KINGBOROUGH DRAFT LOCAL PROVISIONS SCHEDULE – DIRECTION 133 (BURWOOD DRIVE SAP)

1b. Explanation of modifications made to the Burwood Drive SAP

Justification for the modified Burwood Drive Specific Area Plan

Figure KIN-S5.1 – Burwood Drive SAP

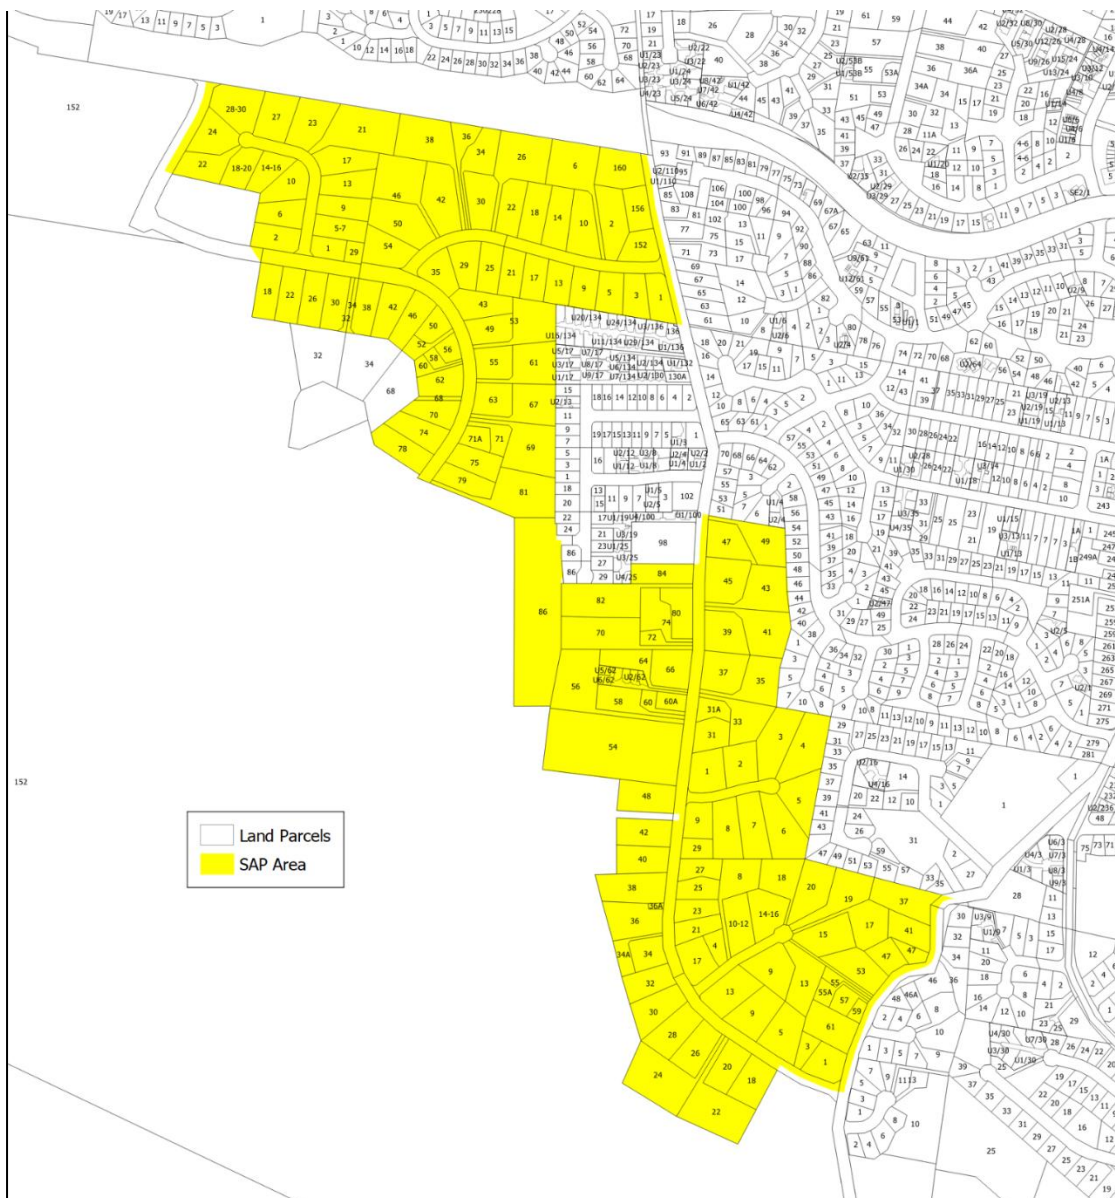
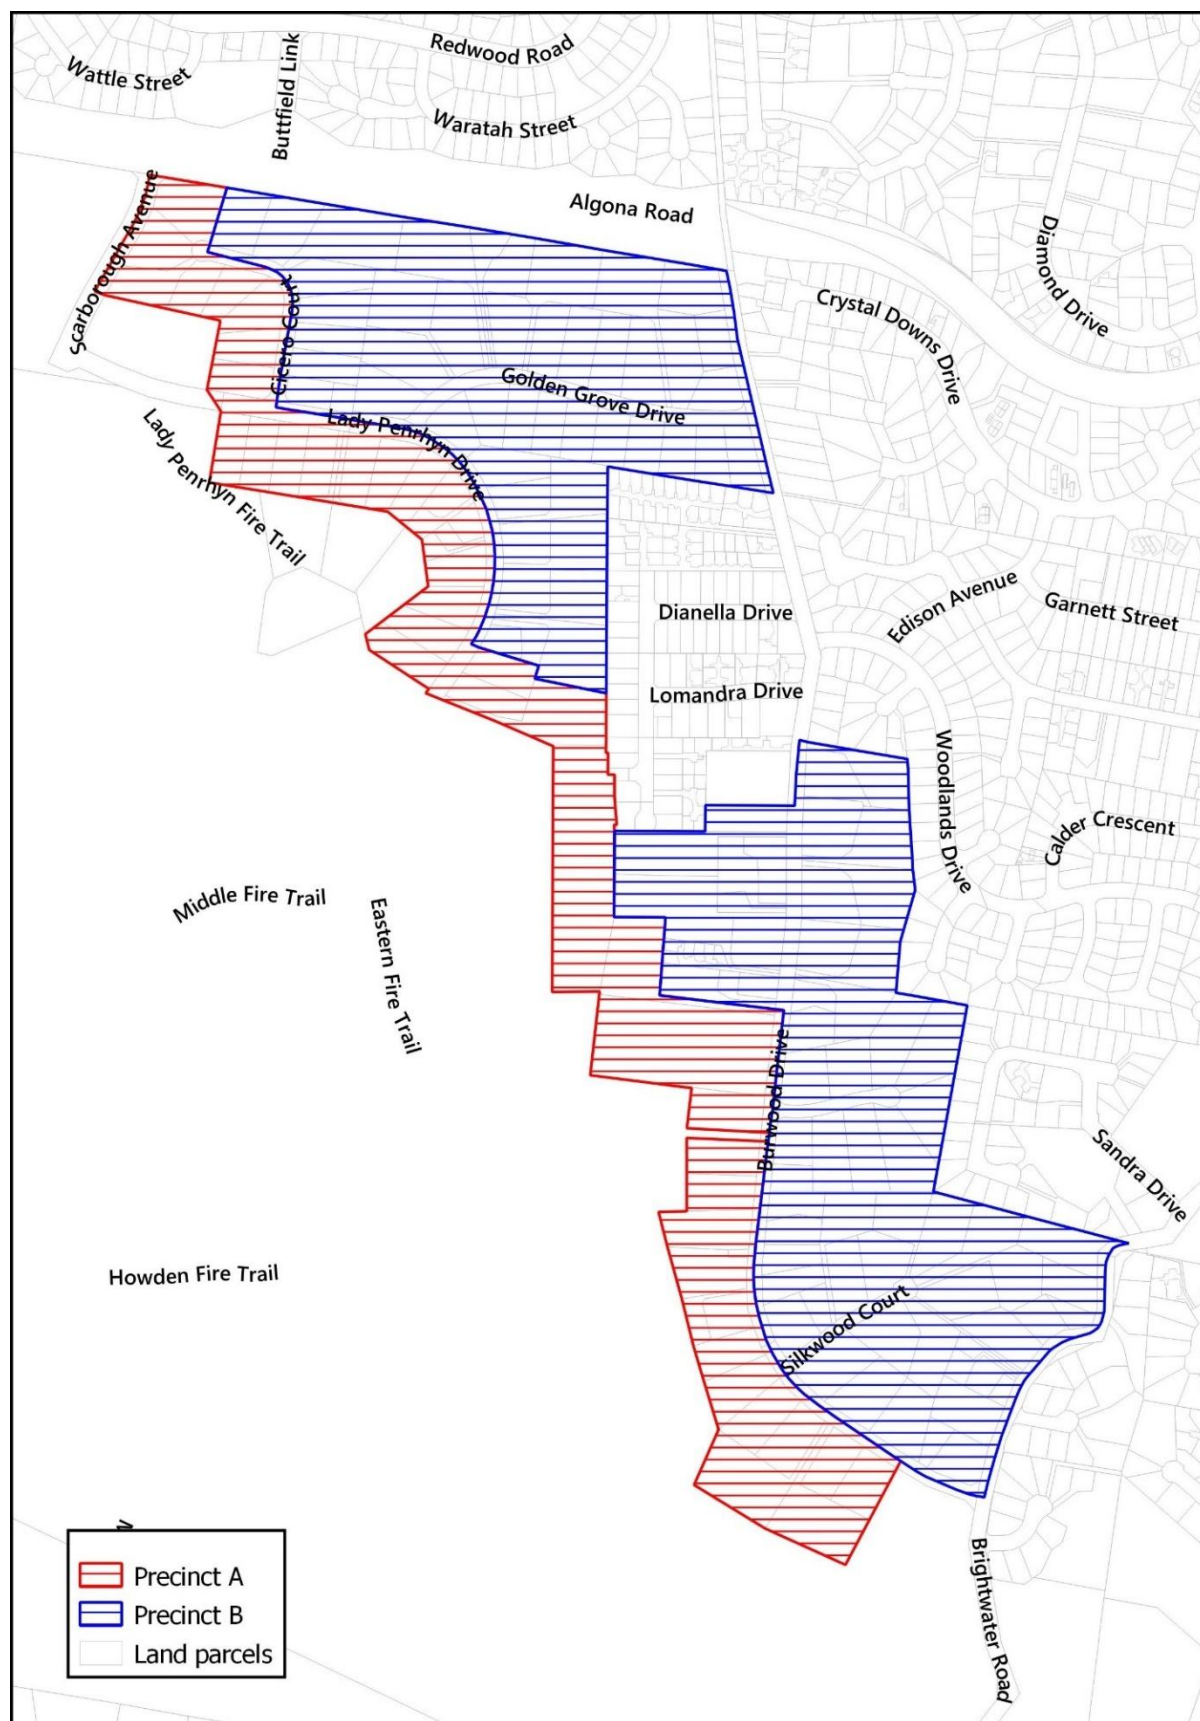
Figure KIN-S5.3.2 – Precincts A and B

Figure KIN-S5.1 – Burwood Drive SAP

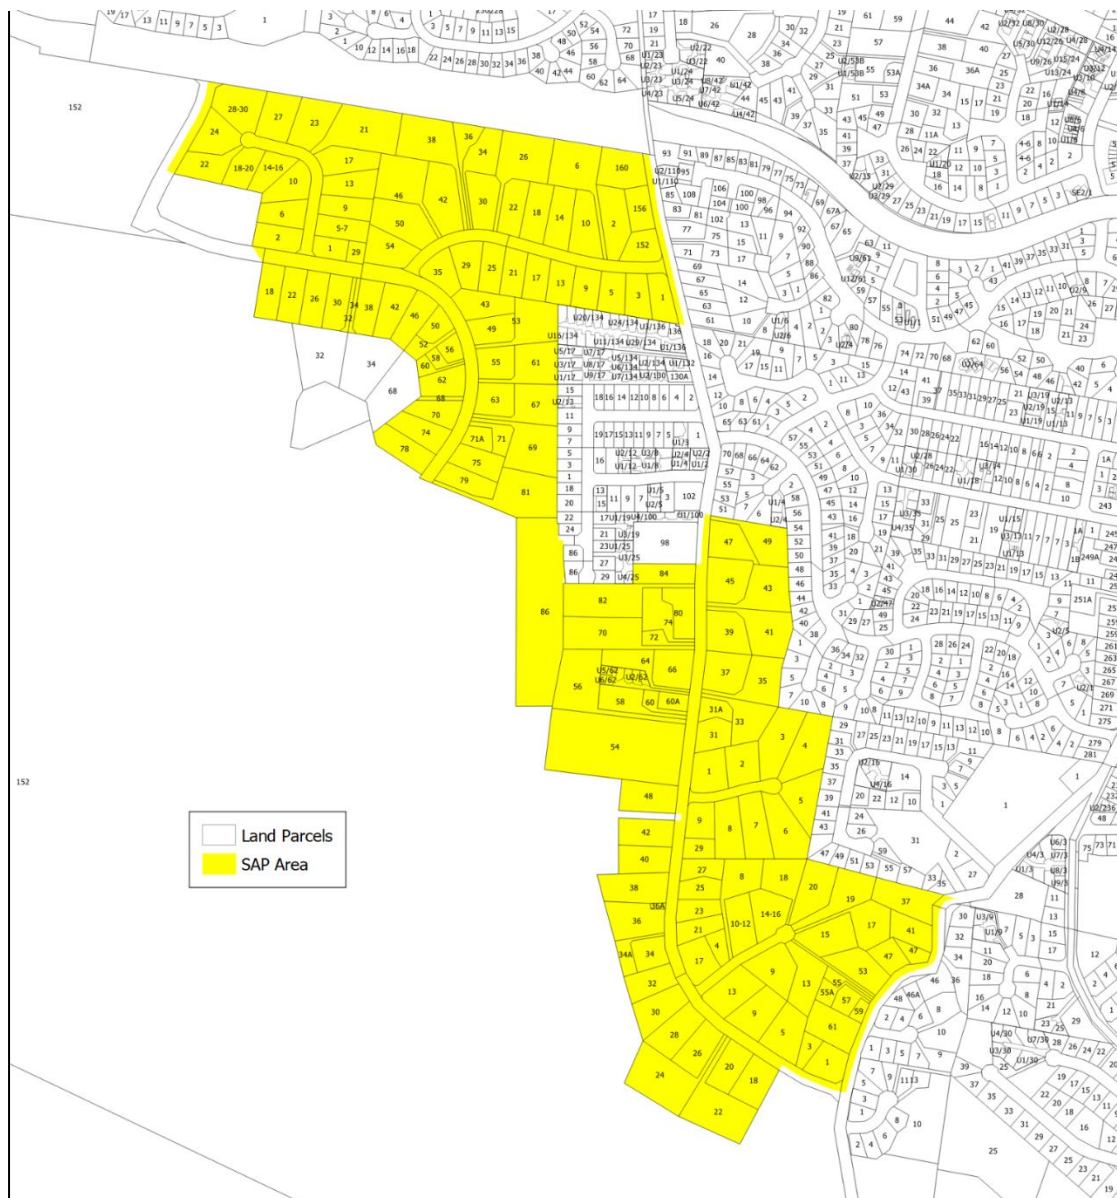
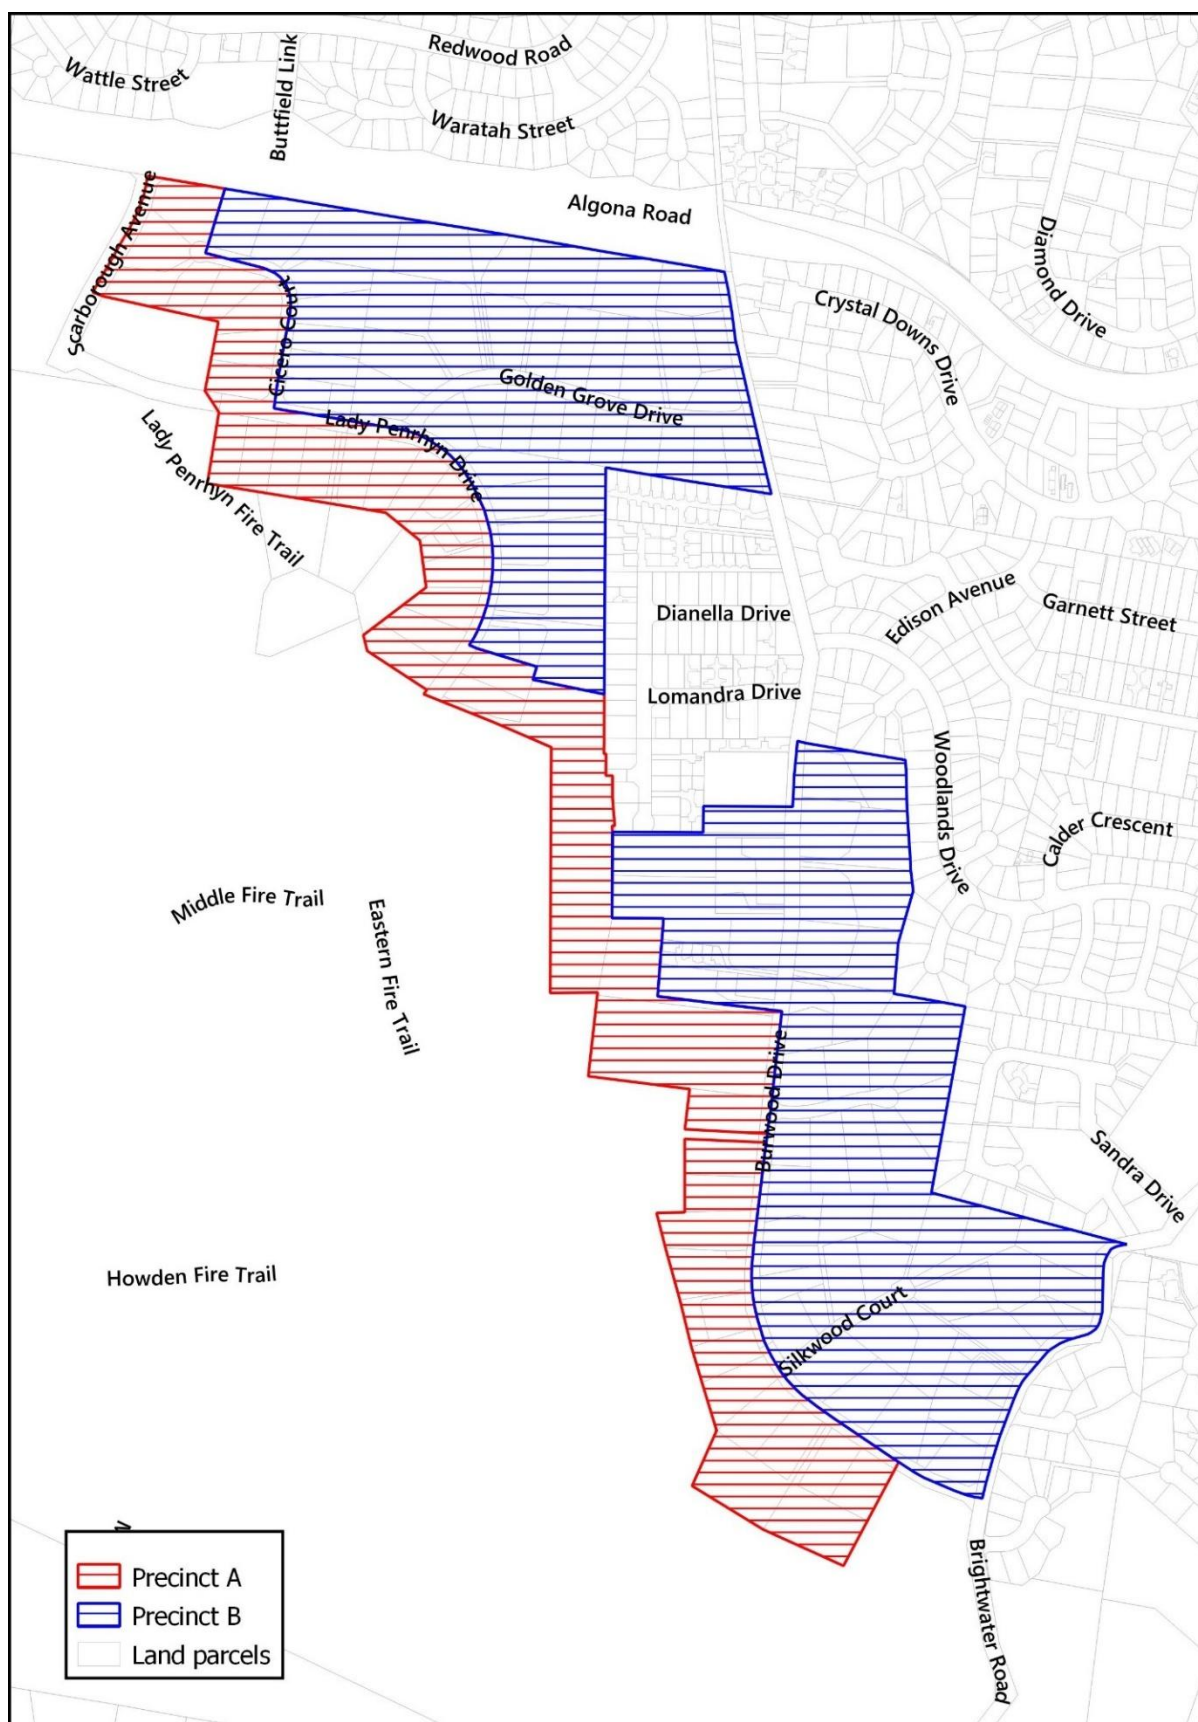
Figure KIN-S5.2 – Precincts A and B
